Addendum Number: 02**Addendum Issue Date:** January 14, 2026**Owner:** Robinson-Palestine Water Commission**Project Name:** Water Treatment Plant and Campus**Project Number:** 0210007.00**Containing:** # Pages; # Drawings; # Specifications

12. SHEET C1 & C2 – PROVIDED as a standalone attachment with the addendum. These sheets pertain to Rte. 1 and Rte. 33 watermain crossing. These sheets were included in the original specifications, as a permit attachment for the aforementioned crossings. The attached sheets with the addendum are a higher resolution version of the of the same sheets that were provided with the original specifications.

PROJECT:
**Robinson-Palestine Water
Commission**

Water Treatment Plant and Campus

SHEET TITLE:
VFD SITE

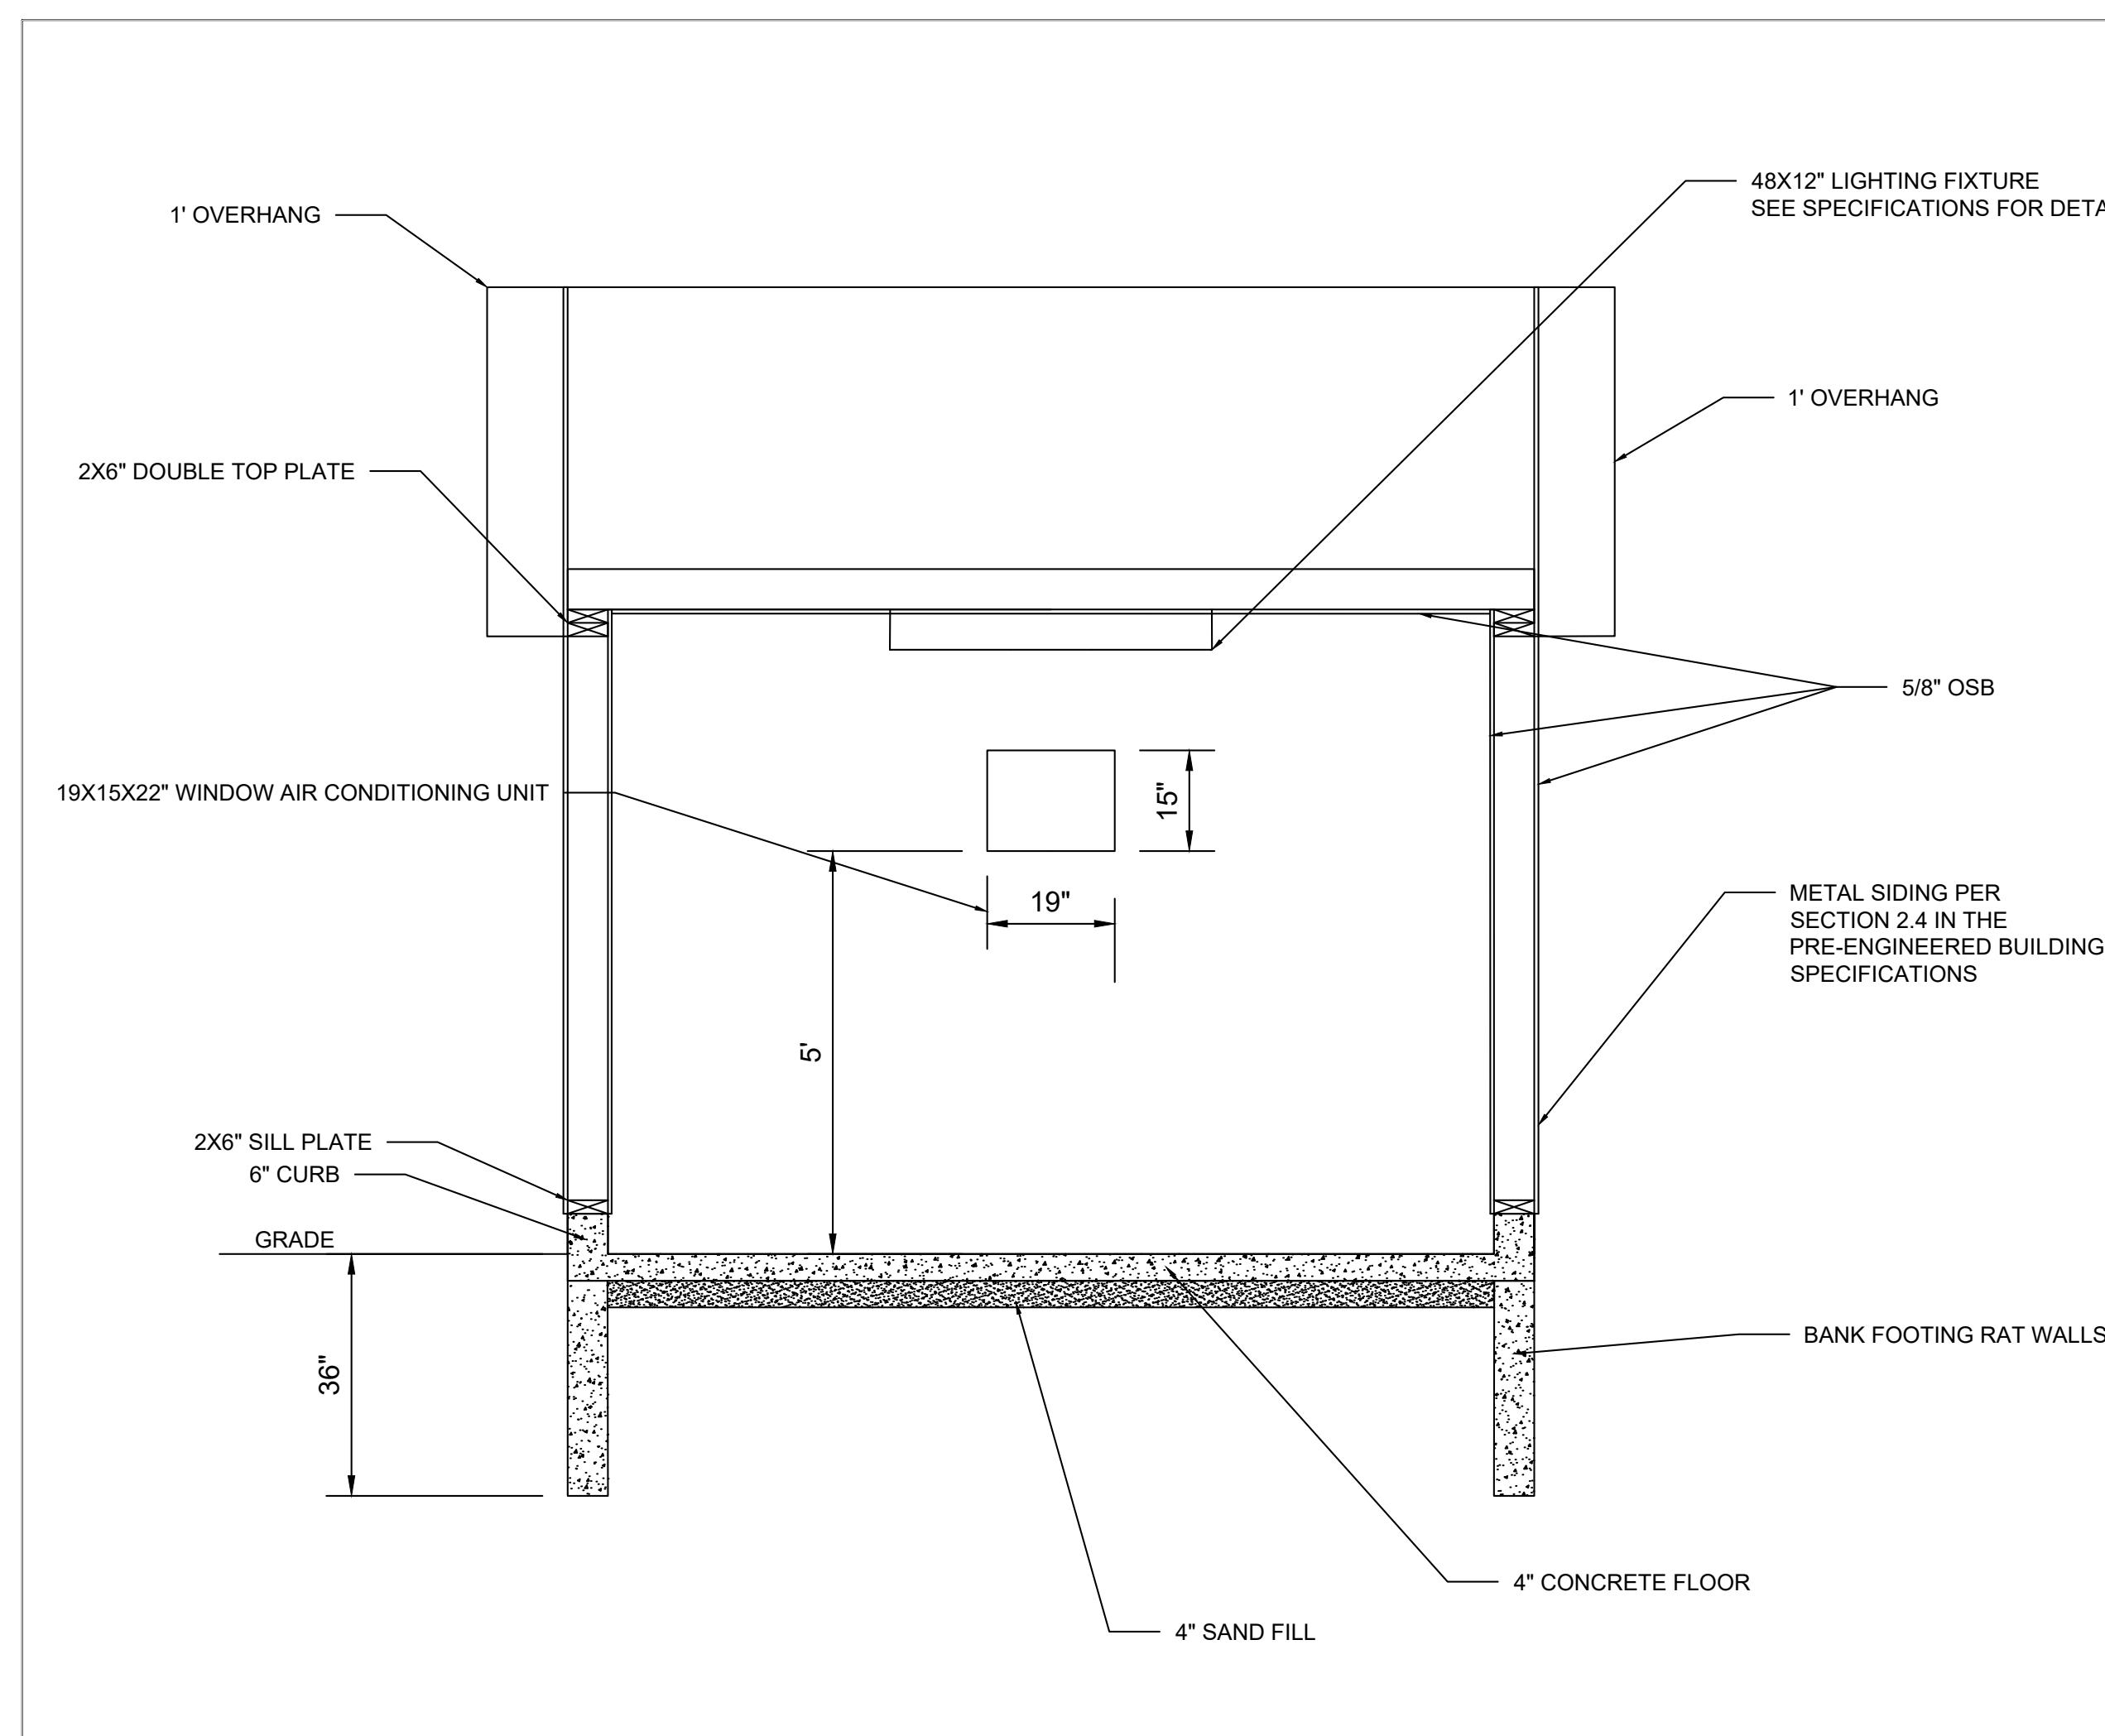
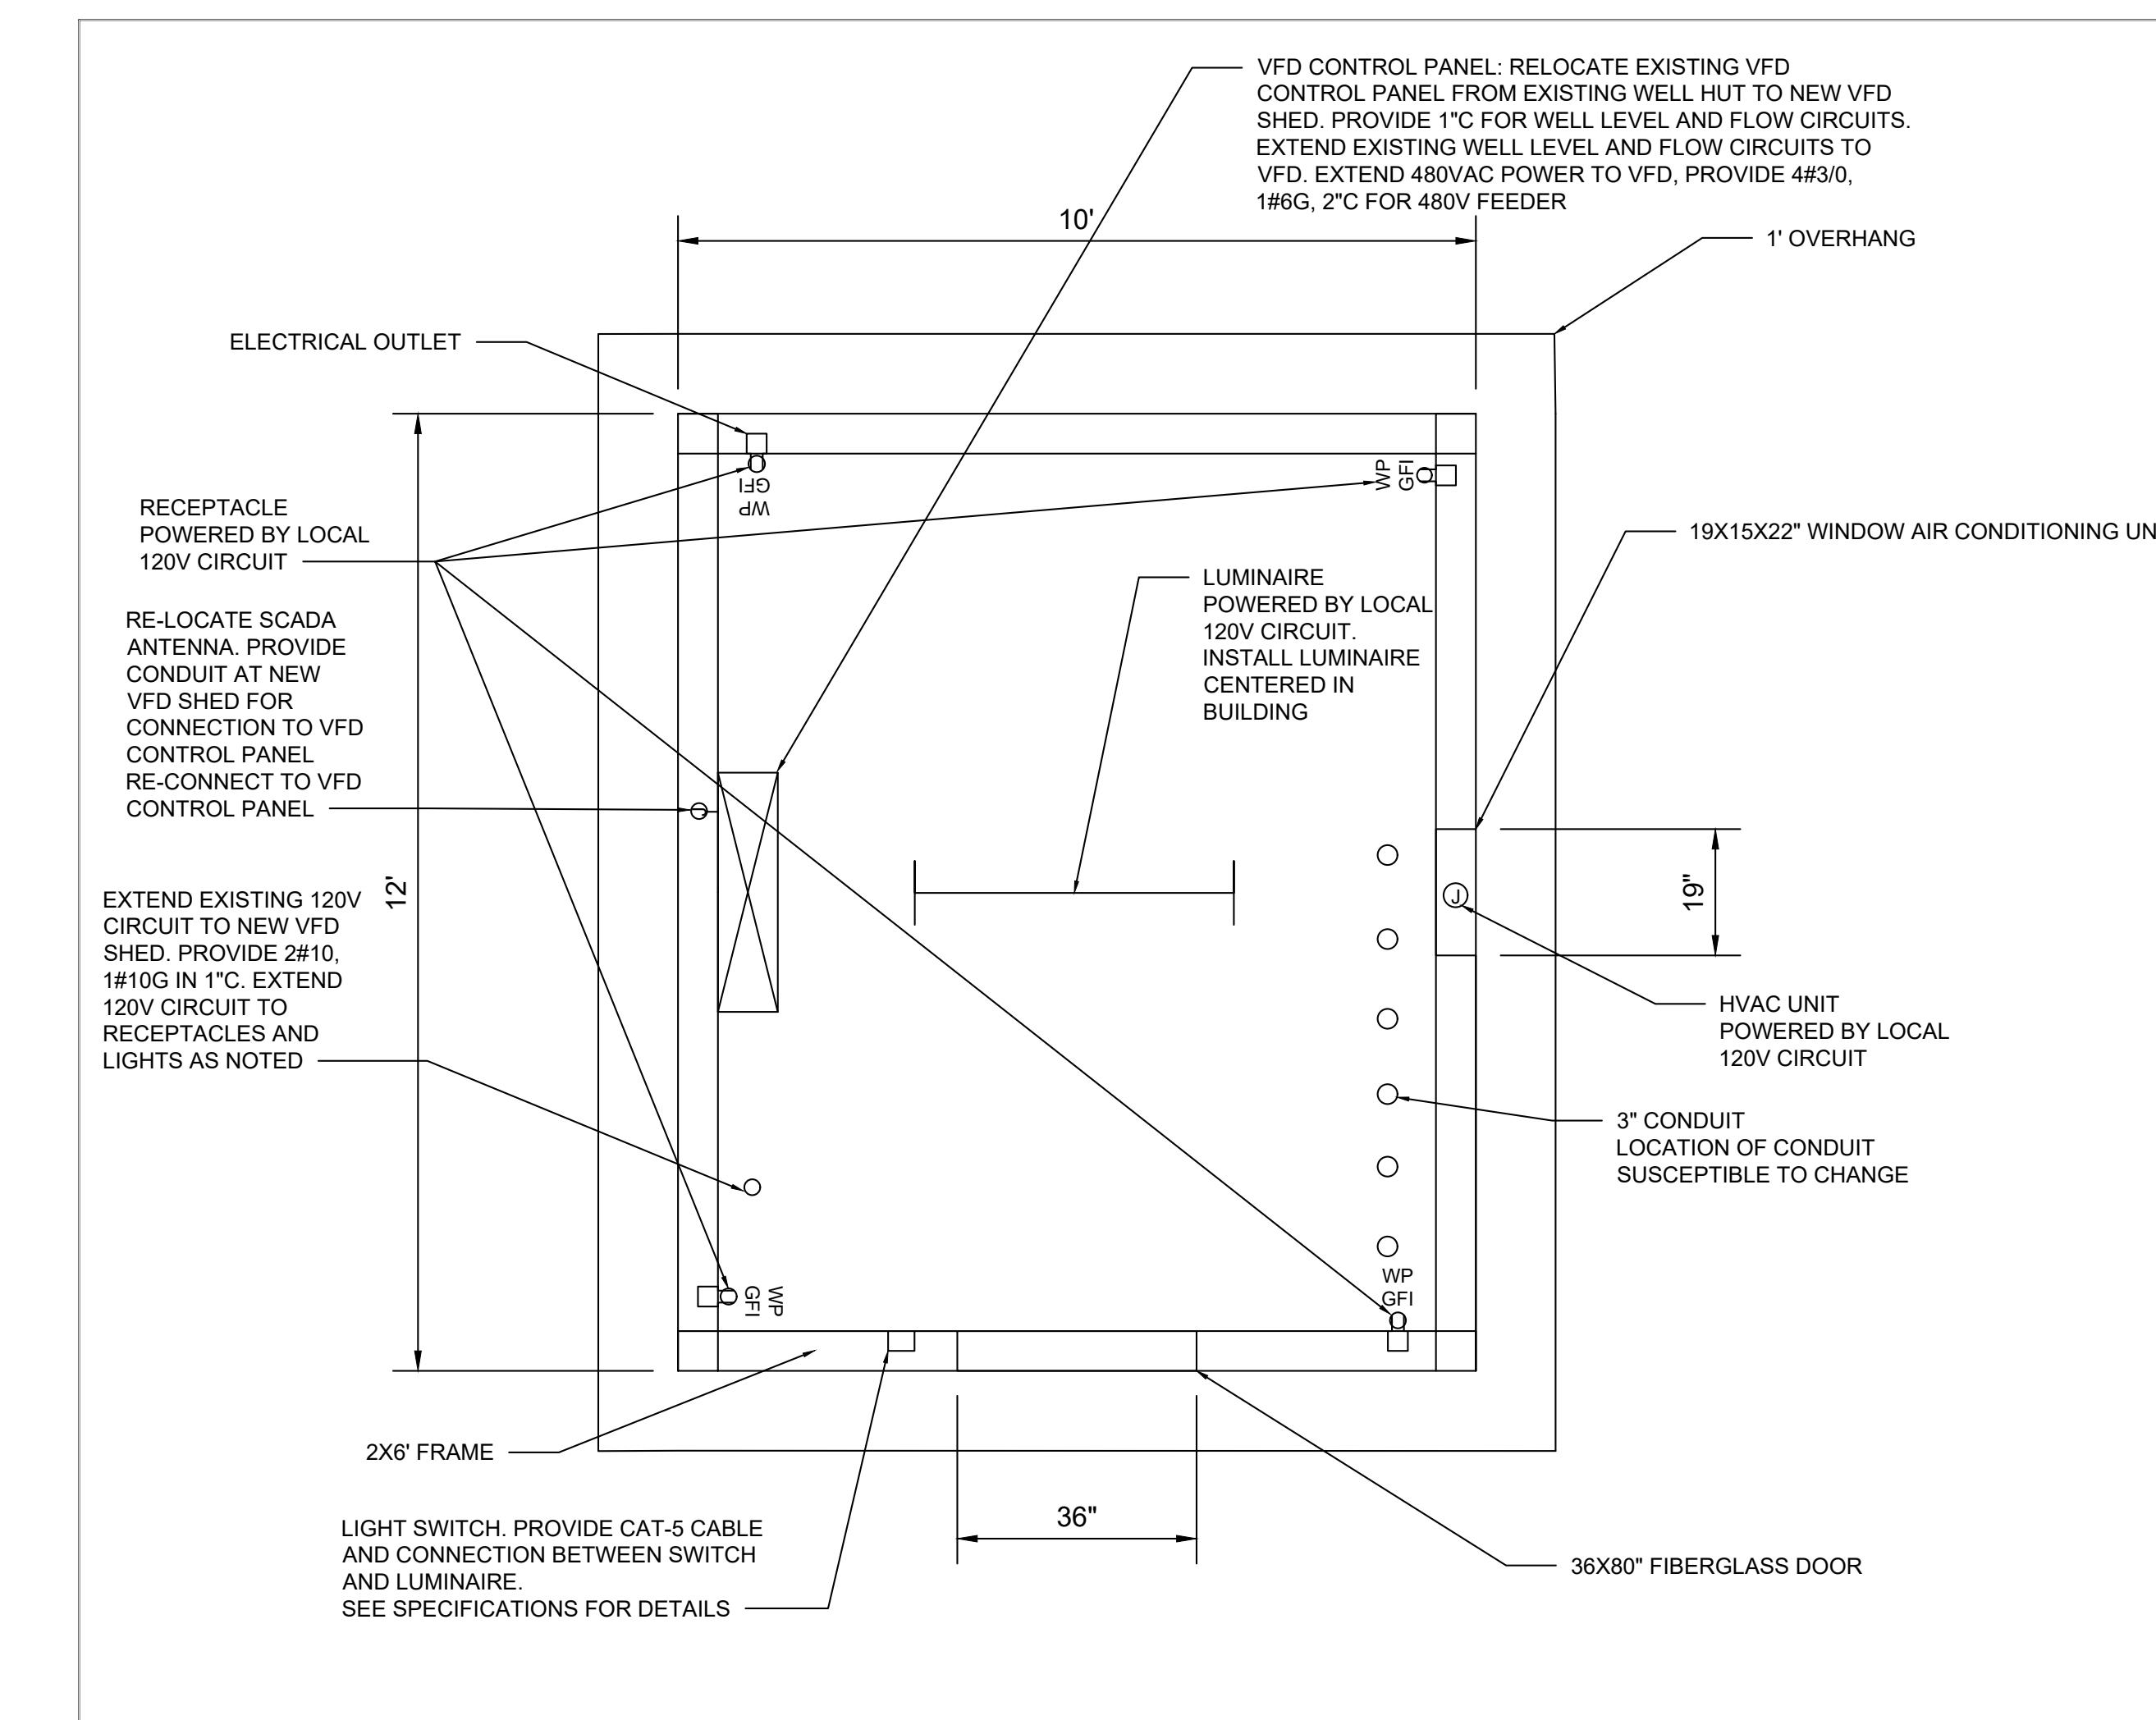
14. SHEET C5.1 TO SHEET 5.3 – ADDED details about VFD Shed for the existing wells, to be included with this contract.

B. AT EACH EXISTING WELL MOVE EXISTING VFD CABINET TO NEW VFD SHED. PROVIDE CONDUIT AND CONDUCTOR FROM EXISTING WELL HOUSE TO NEW VFD SHED TO RE-FEED VFD AND PUMP. PROVIDE LIGHTING AND POWER AS SHOWN ON PLAN SHEETS.

- C. 6" CONCRETE CURBS WILL BE POURED IN ADDITION TO THE CONCRETE FLOOR FOR THE FRAME OF THE BUILDING TO BE BUILT ON.
 - D. SIX 3" CONDUITS WILL BE RAN THROUGH THE FOOTINGS AND UP THROUGH THE FLOORS OF THE BUILDING. LOCATION OF CONDUIT WILL BE SUSCEPTIBLE TO CHANGE BASED ON LOCATION OF THE SHED RELATIVE TO THE WELLS.

- B. PROVIDE LITHONIA LIGHT FIXTURE: CSS L48 7000LM MVOLT MIN10 ZT 35K 80CRI NLIGHT PIR ZACVH M100.
 - C. THE ATTIC VENT WILL BE A BROAN ROOMSIDE SERIES 110 CFM CEILING EXHAUST BATH FAN. MODEL NO: AR110.
